FR02	Flood Risk	<p>An area of the proposed development on the northern side is predicted to be extensively flooded in shallow depth possibly due to inadequate provision of overland flow path. Please check.</p> 	Post Development flood risk	<p>We noticed an added flood flow diversion channel on the upstream side of Grand Drive. This has alleviated flooding at this location.</p>
FR 03	Flood Risk	<p>A normal depth water level boundary is adopted in the HEC-RAS model with a hydraulic gradient of 0.02 or 2% assumed for the receiving estuary channel. A constant tidal level boundary which takes into account of Sea Level Rise (SLR) and Vertical Land Movement (VLM) is considered more appropriate. The SLR scenario should be as per the Coastal Hazards and Climate Change Guideline (July 2024, MfE) for upto year 2130.</p>	Tidal level can have a impact on flood levels.	<p>Tidal boundary has been added at 3.54 mRL -okay</p>

FURTHER REVIEW COMMENTS (after review of latest submitted documents and model files)

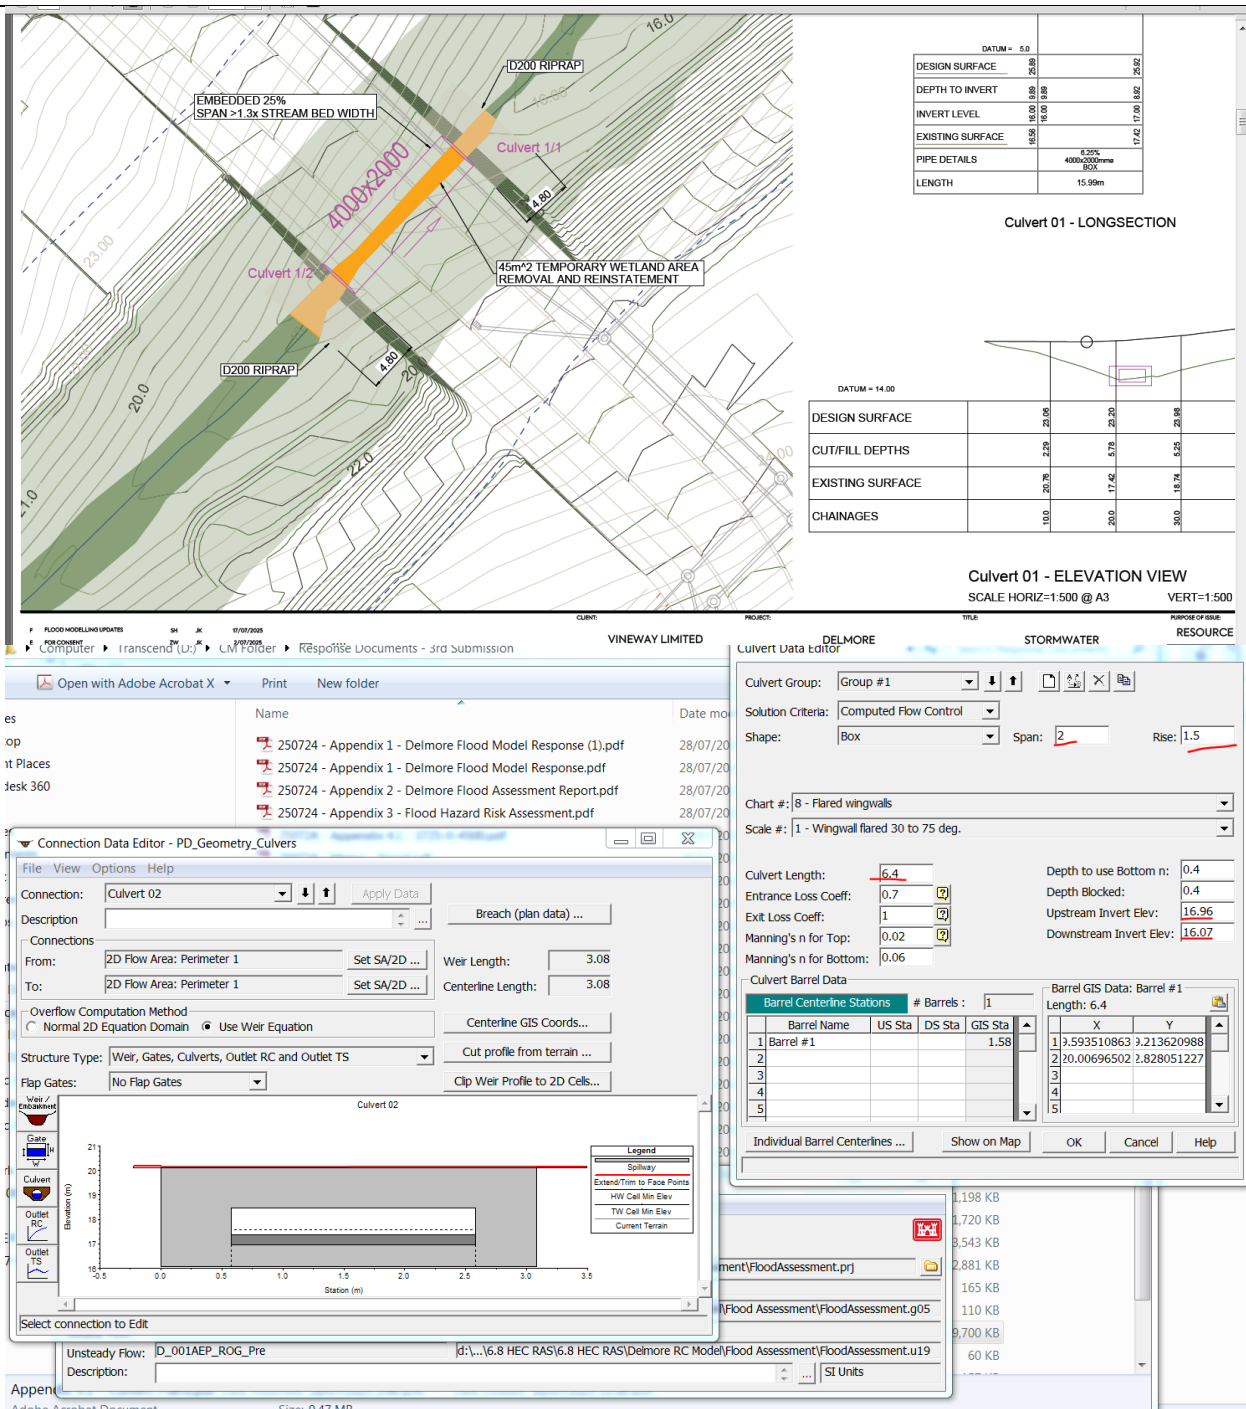
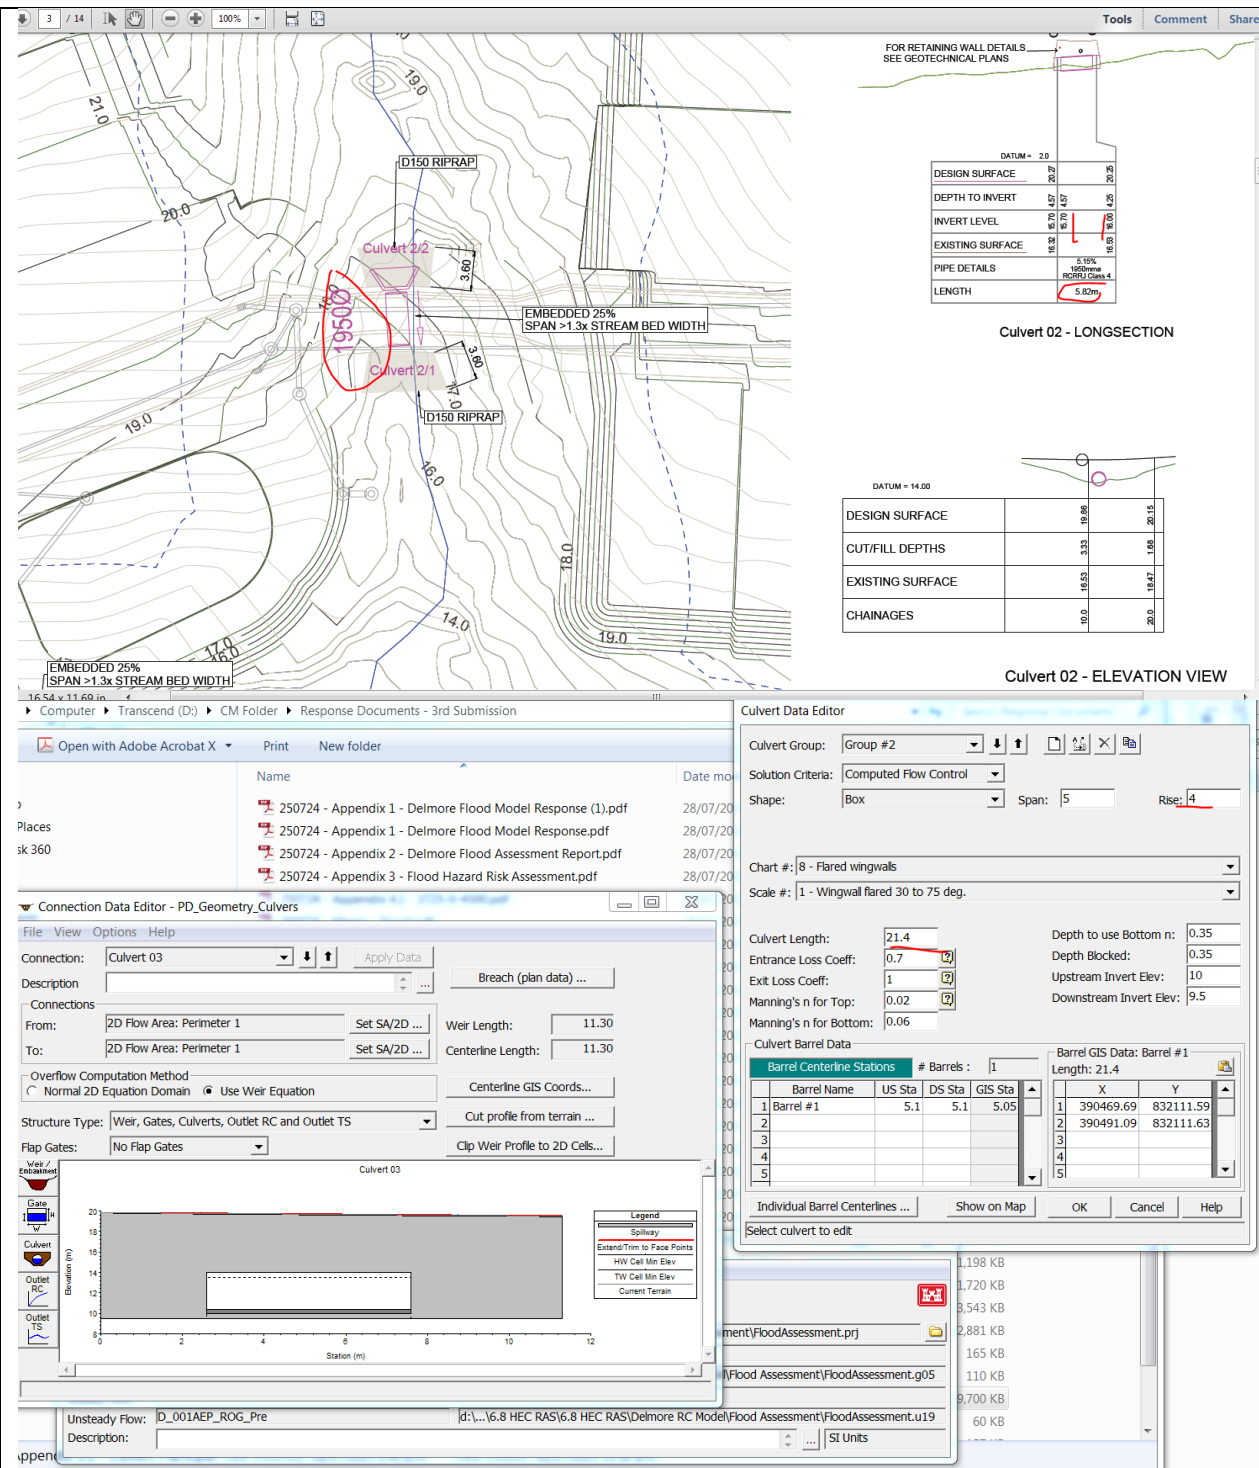
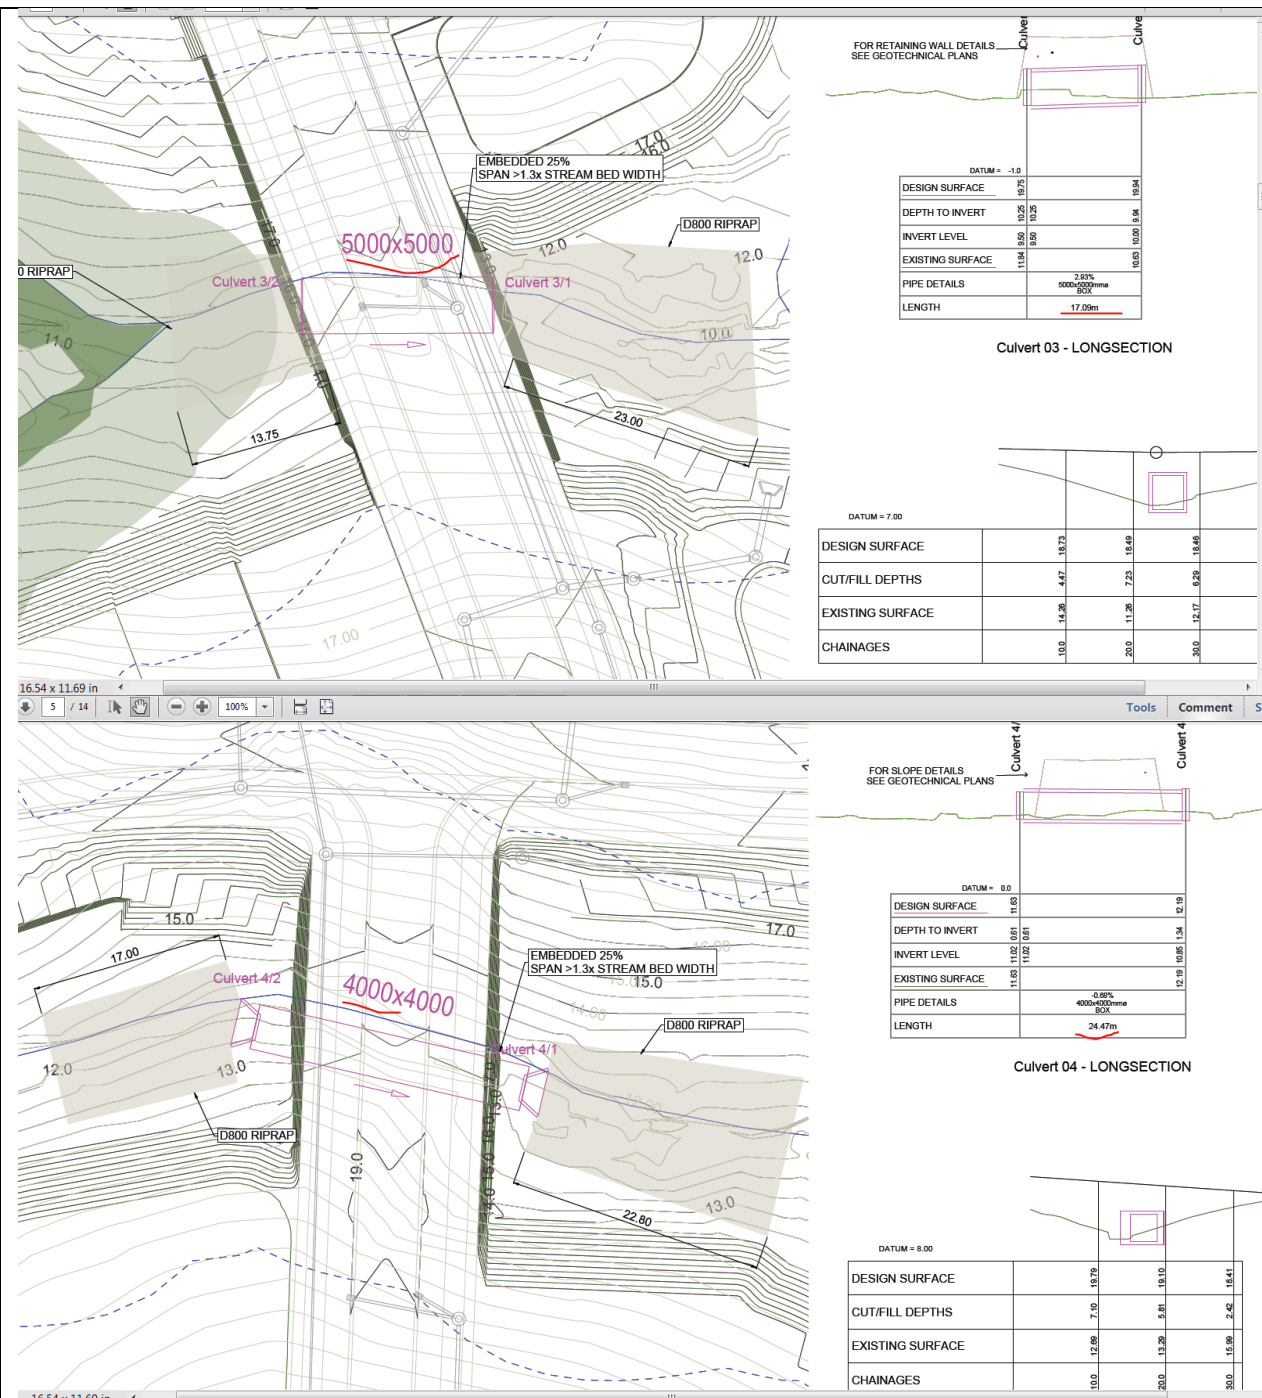
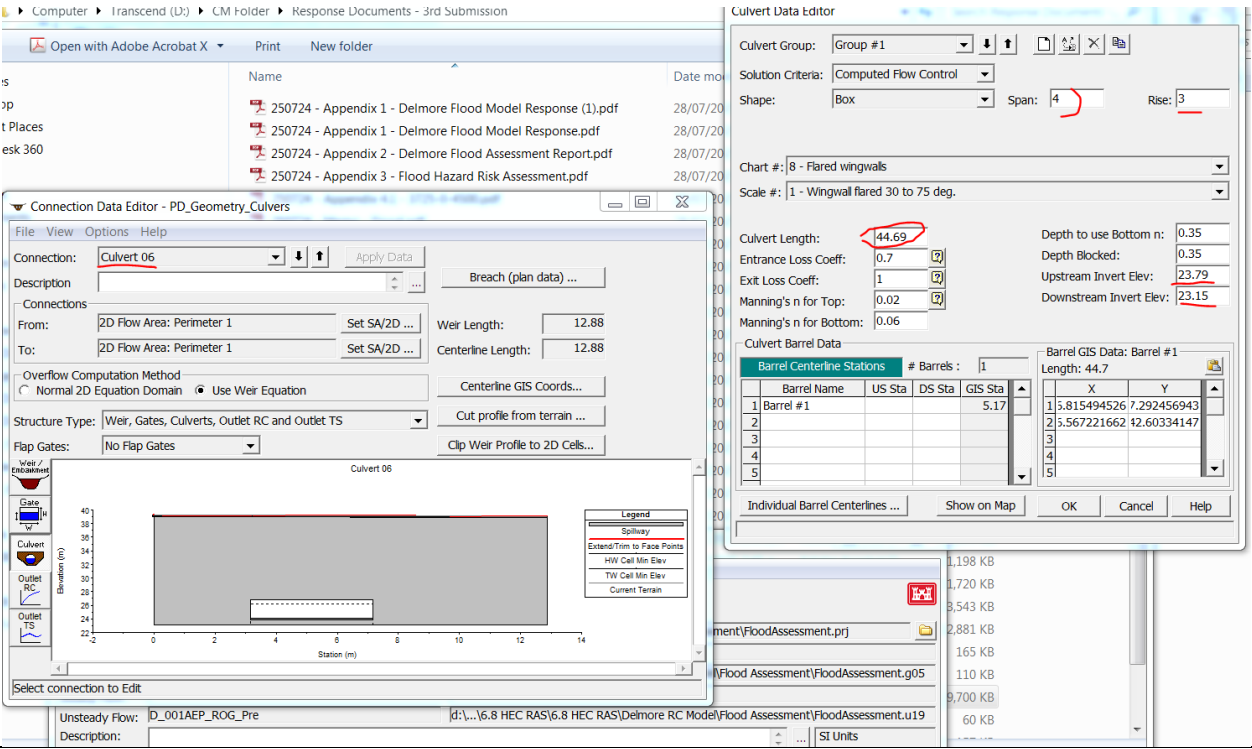
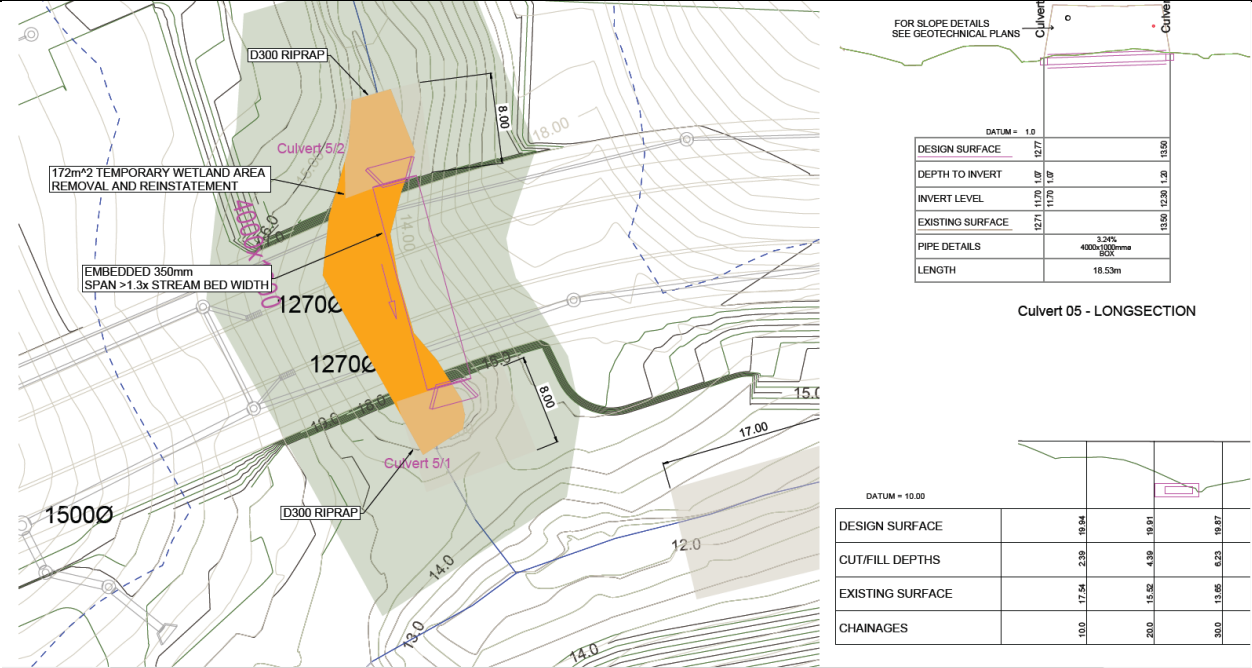
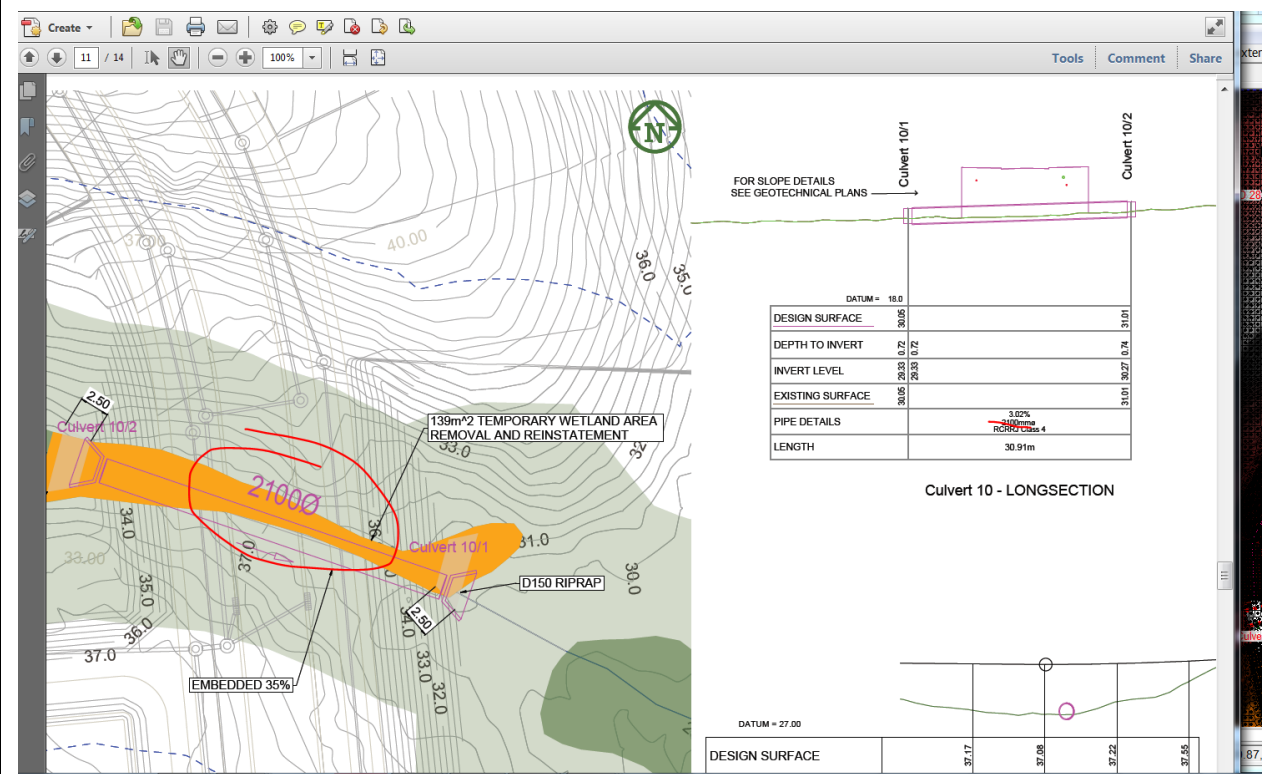
FR13	Model Review	<p>Roughness values for the SH1 reserve area on the western side has been set as 0.02 - this should be higher - may be 0.04, the stream channel downstream the SH1 culvert has been set as 0.1 for roughness, being the same as the private properties to the north. The stream channel area downstream the motorway culvert may be set as 0.06 as per other natural stream channels.</p> 	Minor inconsistencies in modelling data.	
FR14	Model Review	<p>There are many culverts found with differences in sizes, lengths and levels when compared with design drawings. This will need to be checked, and model amended in the future.</p>	Inconsistencies of model data on culverts proposed.

FR15

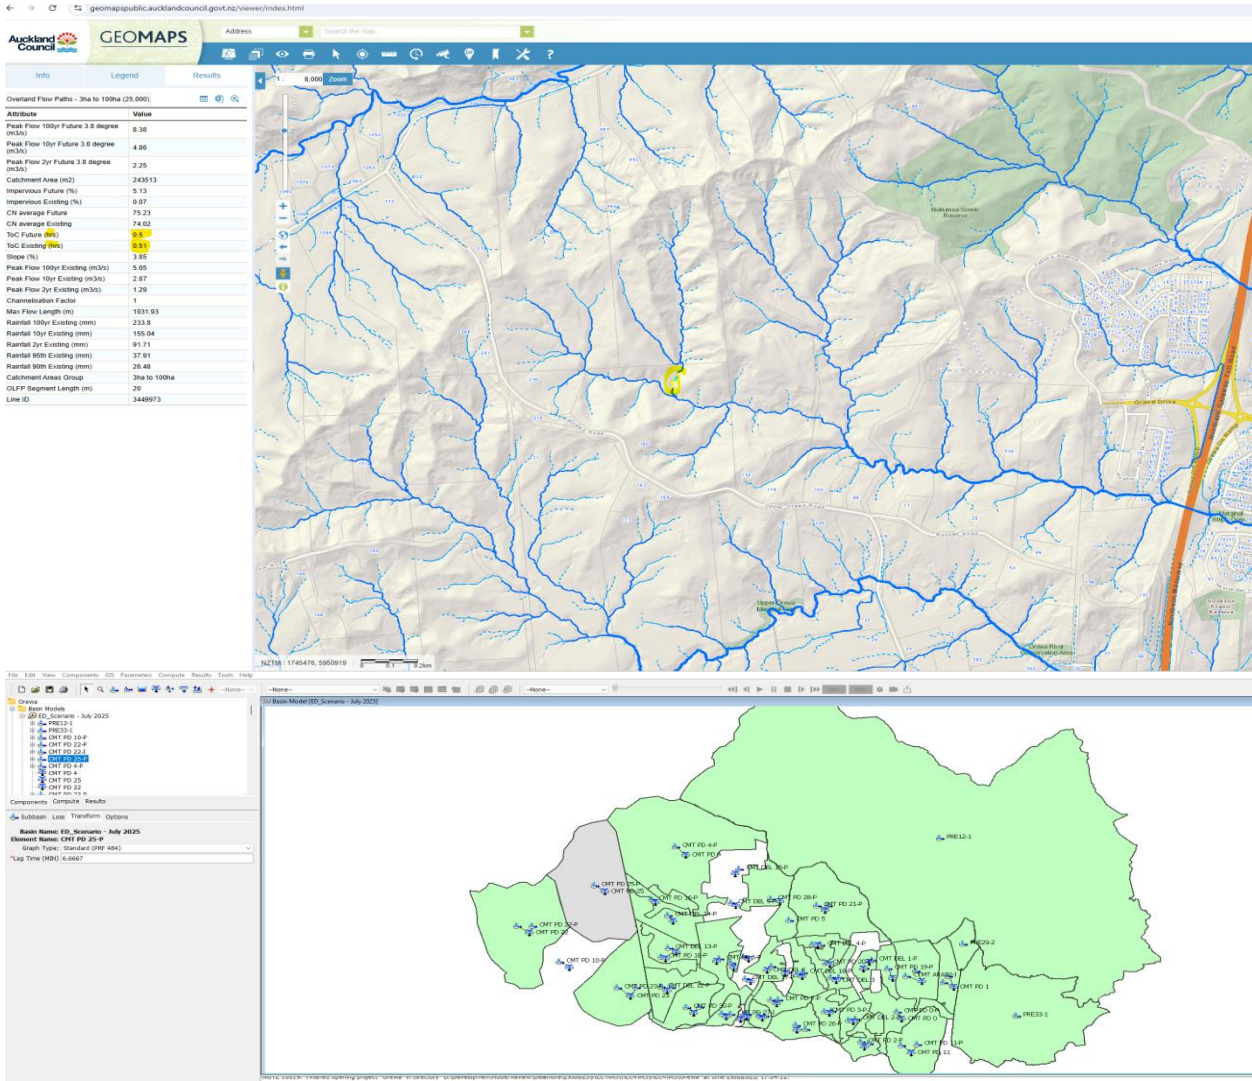
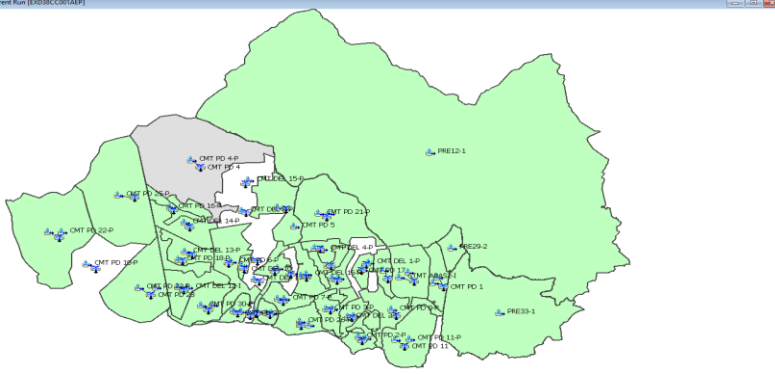
A couple of subcatchments were checked for peak flows and times of concentration comparison with GeoMaps overland flow path data. Differences have been noted especially for Tc.

Model data inconsistencies
